Subject: Issuance of Amendment No. 16 to Facility Operating License  
NPF-9 - McGuire Nuclear Station, Unit 1

AMENDMENT TO FACILITY OPERATING LICENSE

Amendment No. 16  
License No. NPF-9

SAFETY EVALUATION BY THE  
OFFICE OF NUCLEAR REACTOR REGULATION  
RELATED TO AMENDMENT NO. 16  
TO LICENSE NPF-9  
DUKE POWER COMPANY

Figure 6.2-1 Offsite Organization

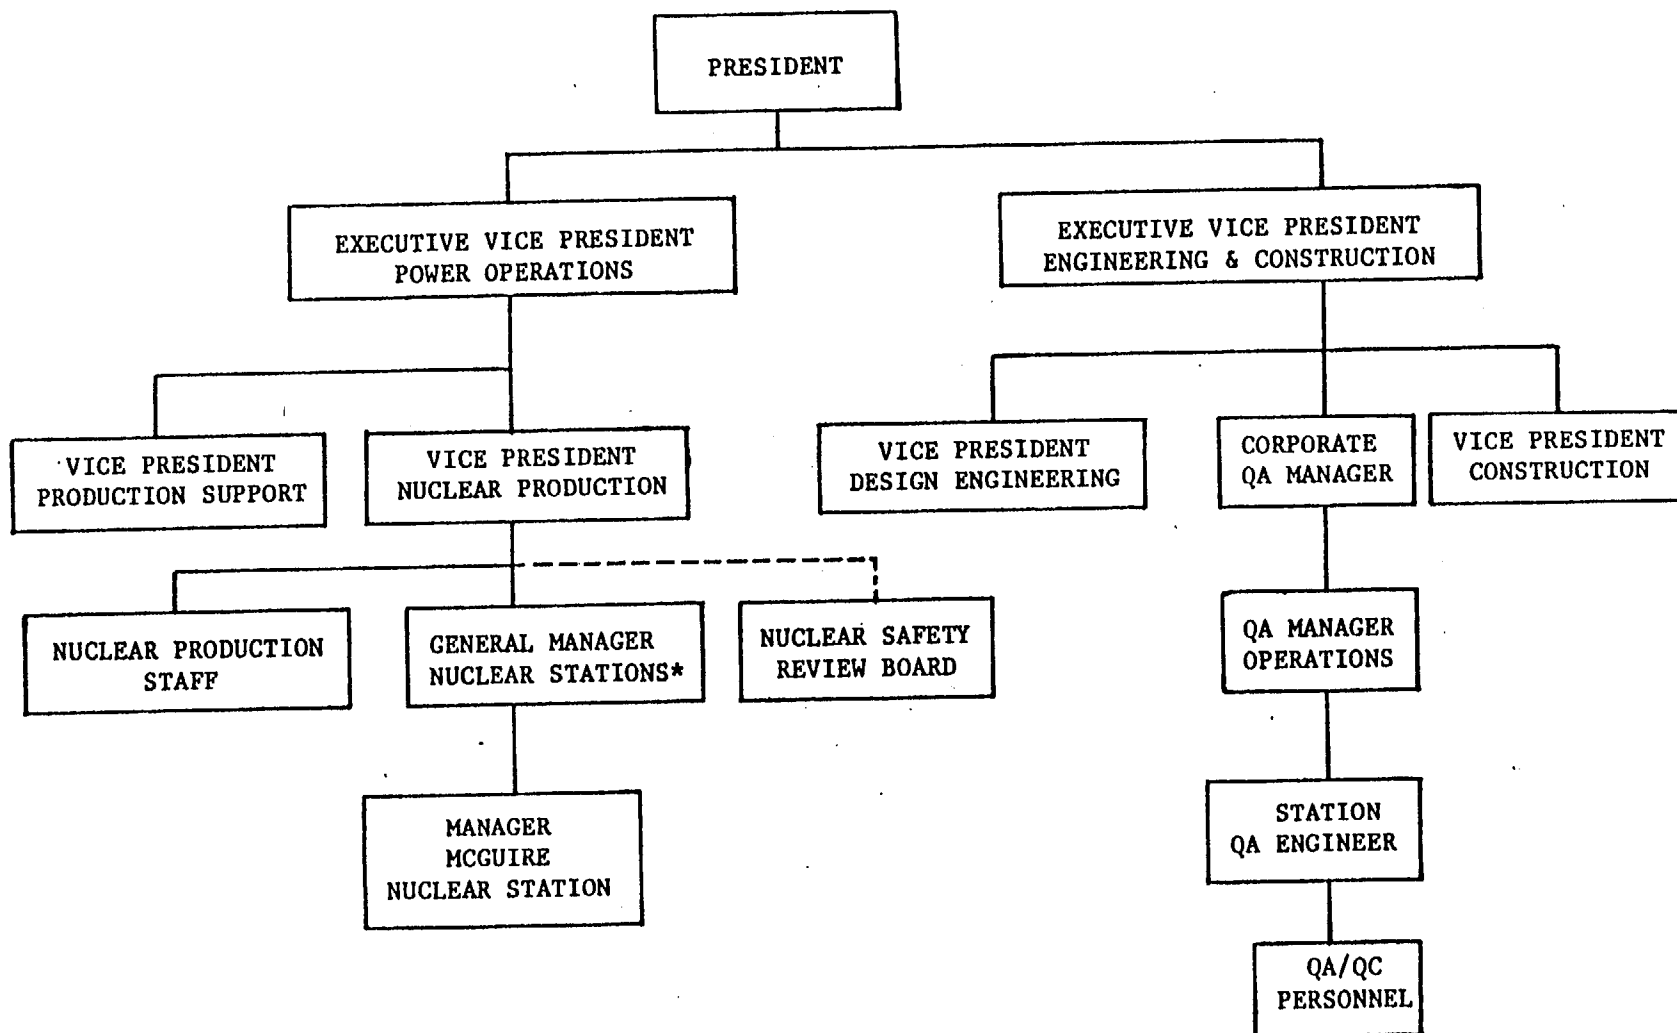
The current McGuire Technical Specifications show the nuclear station manager reporting to the Manager Nuclear Production who in turn reports to the Vice President, Steam Production. The proposed reorganization divides the functions of the Vice President, Steam Production into three positions: Vice President, Nuclear Production; Vice President, Fossil Production; and Vice President, Production Support. Reporting to the Vice President, Nuclear Production will be a General Manager, Nuclear Stations to whom the Nuclear Station Managers will report. Also reporting to the Vice President, Nuclear Production will be a Manager Nuclear Reliability Assurance, Manager Nuclear Safety Assurance, Manager Nuclear Operation, Manager Nuclear Maintenance, Manager Nuclear Technical Services, Manager Nuclear Engineering Services, Manager Nuclear Administrative Services and Manager Nuclear General Services.

Based on our evaluation, we consider that these proposed changes provide for better integration of those functions needed to support the operation of the nuclear station under a single high level corporate official and are acceptable. This is shown in the revised Technical Specifications Figure 6.1-2 and numerous text changes.

Figure 6.2-2 Station Organization

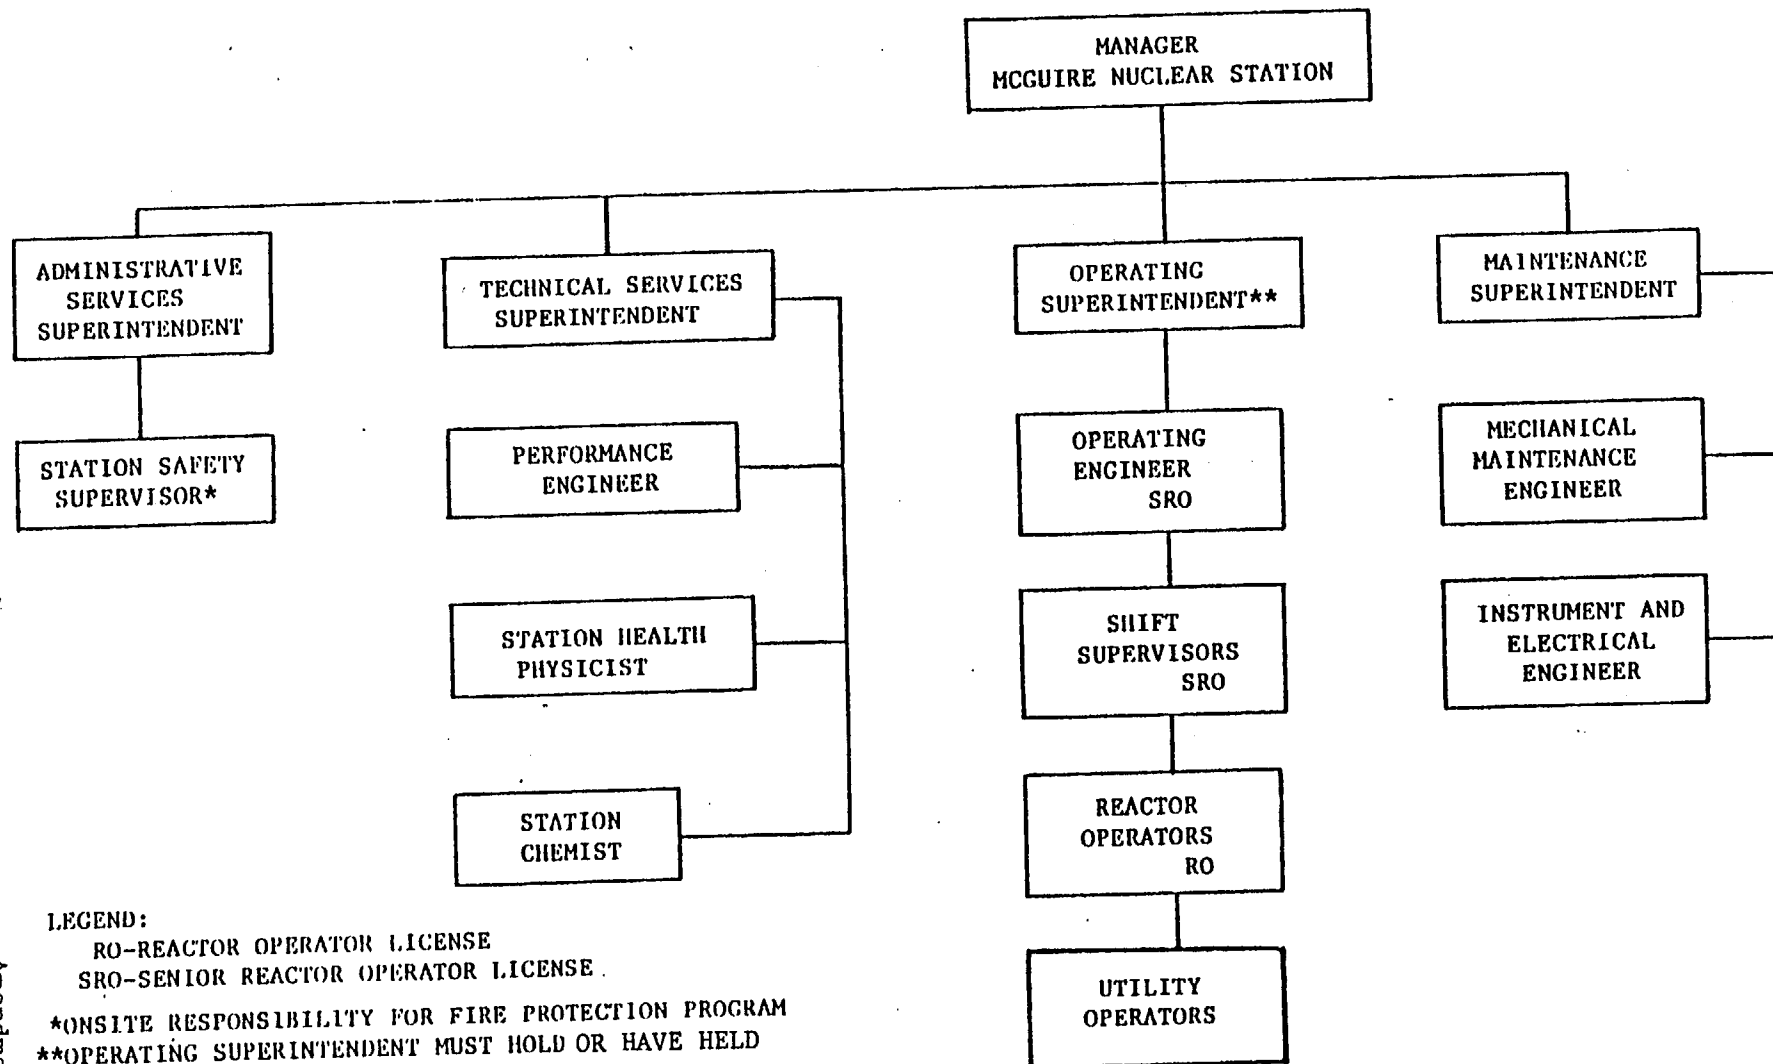
The current Technical Specifications show the Shift Supervisors reporting directly to the Operating Superintendent, who meets the qualification requirements for Operations Manager of Section 4.2.2 of ANSI/ANS 3.1-1978, "American National Standards for Selection and Training of Nuclear Power Plant Personnel," with an Operating

to upgrade the qualifications of the Shift Operating Engineer to that of the Operations Manager of Section 4.2.2 of ANSI/ANS 3.1-1978, and place the Shift Operating Engineer in a line position between the Shift Supervisors and the Operating Superintendent. This organization is reflected in revised Technical Specification Figure 6.1-1. The licensee proposes to alter the qualification requirements for the Operating Superintendent such that he must hold or have held a senior license on the unit.

Based on our evaluation, we find that the proposed organizational change is acceptable since the Shift Operating Engineer will meet the qualification requirements for the individual performing the function of Operations Manager of Section 4.2.2 of ANSI/ANS 3.1-1978 and meets the staff position of Revision 1 to Regulatory Guide 1.8.
